Re: PLANO ZONING CASE #2022-003

Response to Medical City of Plano's Zoning Exhibits and Explanations

Aspen Court Apartment's Response to Medical City Plano's Zoning Exhibits and Explanations

*Evaluation
of the
Proposed Rooftop Heliport
At
Medical City of Plano*

Figure 11
Noise Footprint of a Helicopter Approaching from the North
and Departing to the East or Southeast

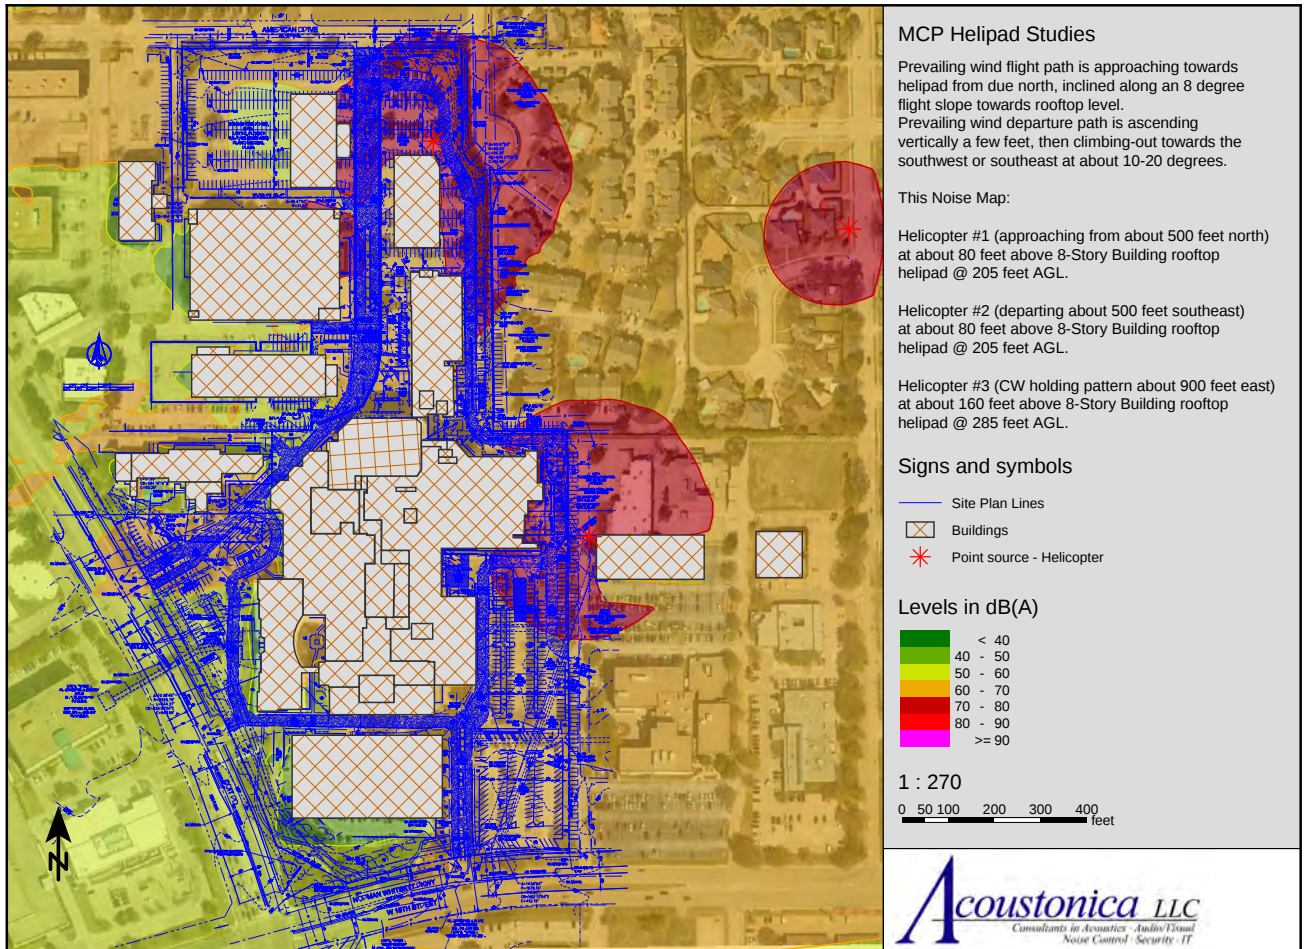
Figure 11 shows the noise footprint and the potential flight paths. Again, the residents on the east side of the heliport will be subject to noise levels that far exceed the City of Plano ordinance. The circle to the east (right on the chart) shows the noise footprint if the helicopter is orbiting at 285 feet above the ground.

These charts and the noise data supports conclusion is that any approach from the north, south or east will subject the residents of Aspen Court Apartments, Park Bluff Condominiums, and the homes in Amelia Court to unacceptably loud noise from approaching and departing helicopters.

Figure 12
Heliport Obstacles and Aspen Court Apartments

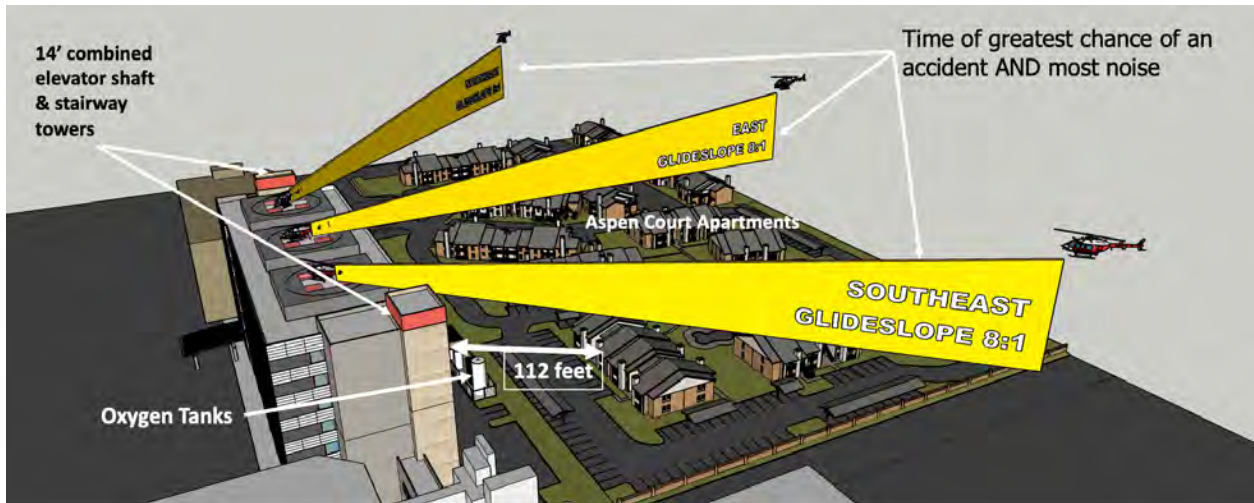
As designed, the structure will have a combined elevator shaft and stairway opening at the north end and another one in the southeast corner. When approaching from the north with a south, southeast, or southwest wind, for the helicopter to land on any of the pads, it will have fly around the towers. If it is approaching from the south, there is a tower in the southeast corner of the pads that provide an obstruction.

Figure 12 is an architectural rendering of the elevator towers and shows the proximity of the proposed building to Aspen Court Apartments and the flight paths of helicopters approaching from the northeast, east and southeast. In the architectural rendering, the two 14-foot tall, combined elevator shaft and stairway are clearly visible and the reader can see the hazard they present to approaching helicopters.

*Figure 13
Flight Path Approaching from the East*

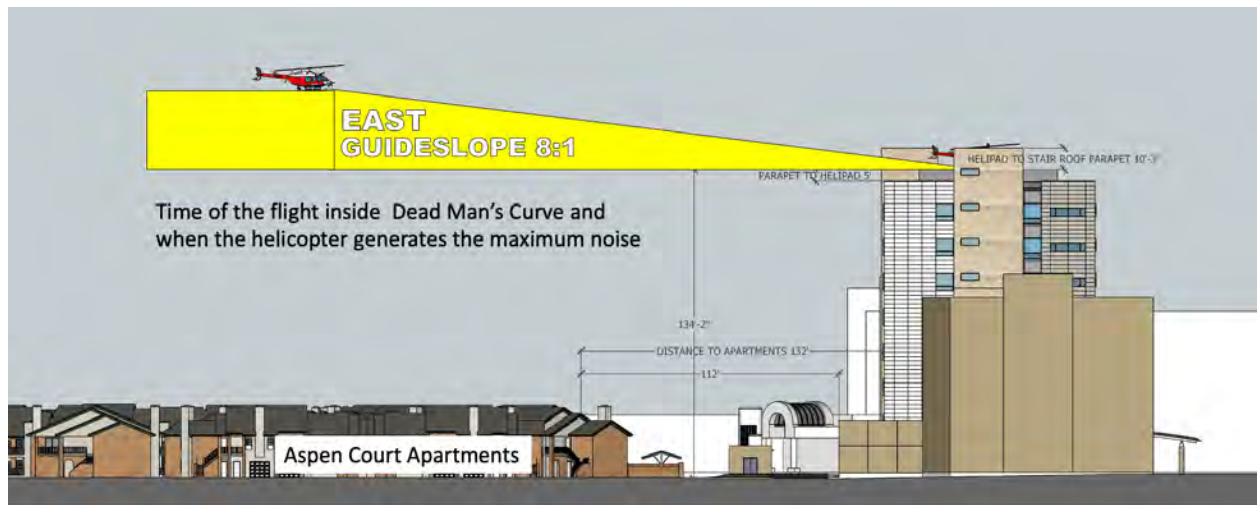
Figure 13 shows the flight path of a helicopter approaching the proposed helipads from the east. Note that for the third phase of the flight, it will be flying low over Aspen Court Apartments as it transitions from forward flight to a hover. This is the portion of the mission when it will be hovering out of ground effect and at high power settings so it will be making the most noise.

(Excerpted from the BAI report)

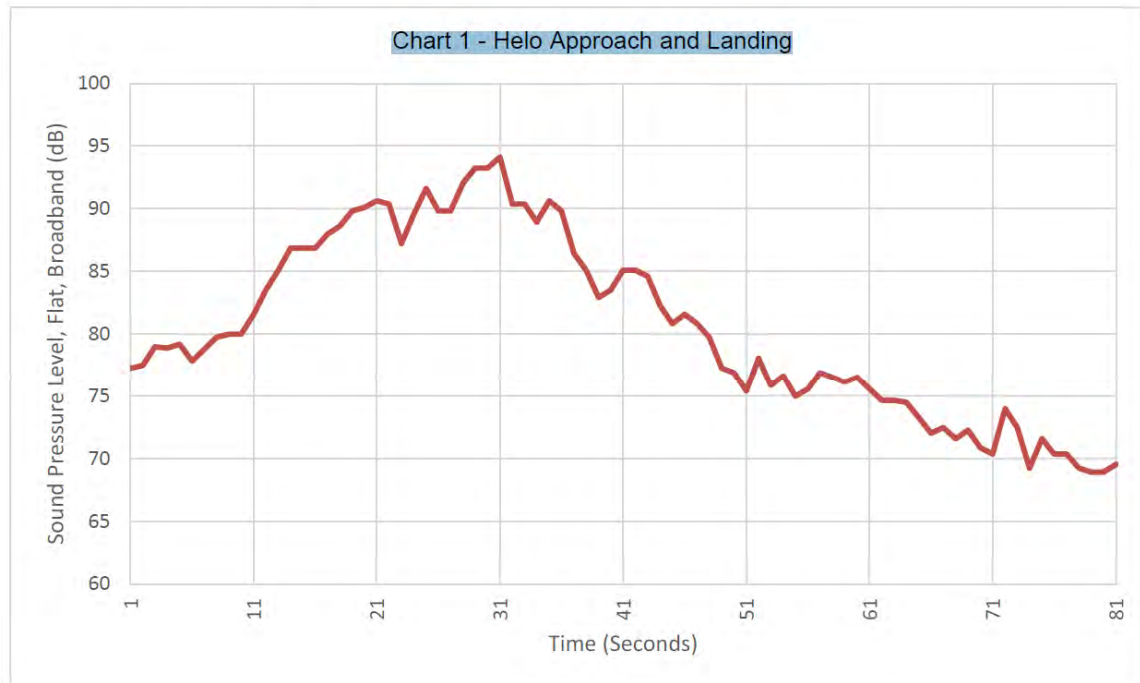
The maximum sound pressure level of 94 dB at 31 seconds occurs when the helicopter is on the approach path exactly perpendicular from the measurement location on the property line. The following chart shows the 1/3 Octave Band Frequency Sound Pressure Levels at the 94 dB maximum.

The decreasing sound level after the 31 second mark is disingenuous as the helicopter was going behind the existing 4 story Tower C and there was no line-of-sight sound exposure to the Aspen Court Apartments.

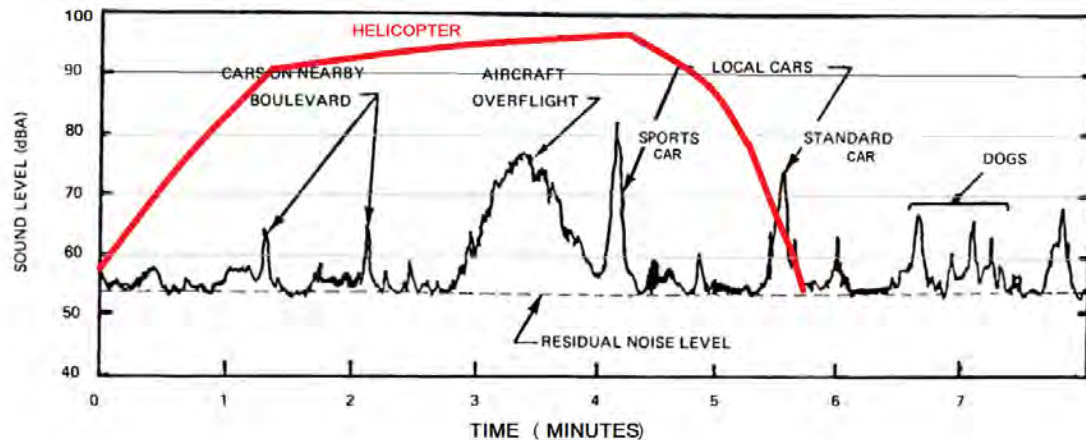
The following noise exposure graph is more representative of the sound levels and durations which the residents of Aspen Court Apartments will experience. Note that the red line occurs twice for each event – once upon approach,

and again upon departure. The warm-up period just prior to departure may extend from a few minutes to possibly ten minutes depending upon weather conditions and other preflight operations the pilot deems necessary.

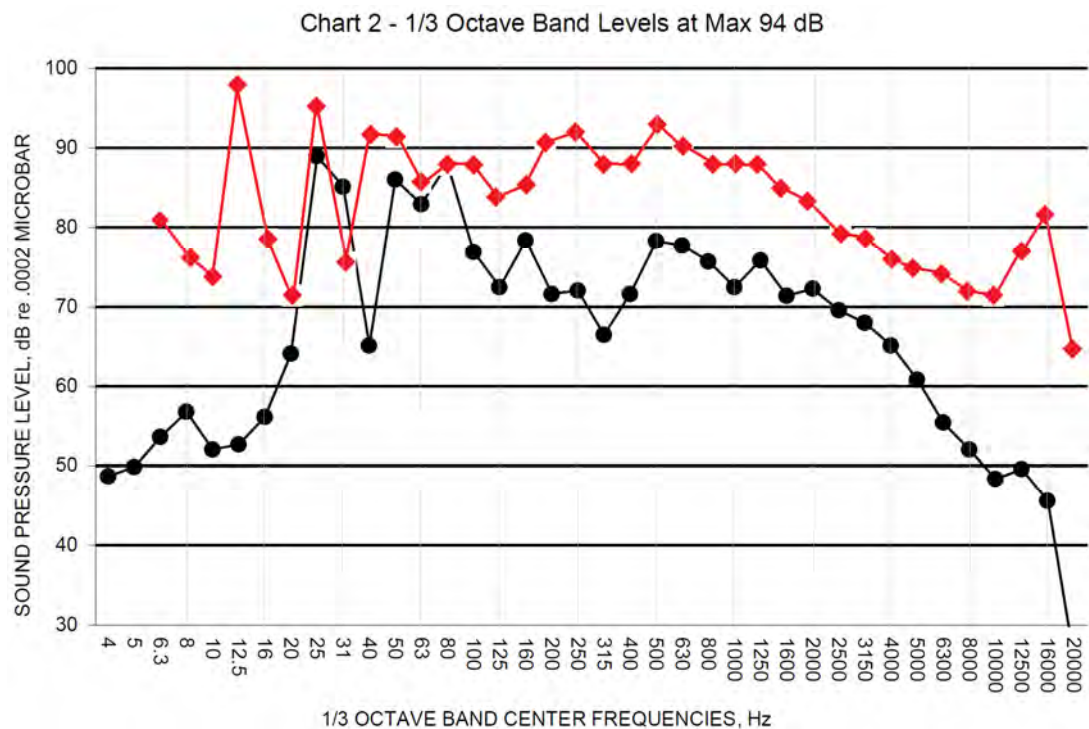
- e. **Not** mentioned in the BAI report, *but quite obvious*, is that whenever helicopters are operating to the east of Tower C (Building #3), the sound from the helicopter(s) will not only come directly from the helicopter(s), but there also will be a substantial sound reflection from the face of each of the buildings that surround Aspen Court Apartments. This includes, but is not limited to:

- i. Building #2 – Future MOB - 2 stories tall
- ii. Building #3 – Tower C – 8 stories tall
- iii. Building #4 – Medical Surgical Tower – 4 stories tall
- iv. Building #5 – Future MOB - 4 stories tall
- v. Building #9 – Future Parking Garage - 10 stories tall

Each of these buildings have *additional* stair and elevator towers, too, which further increases the sound reflective surface areas facing the residents.
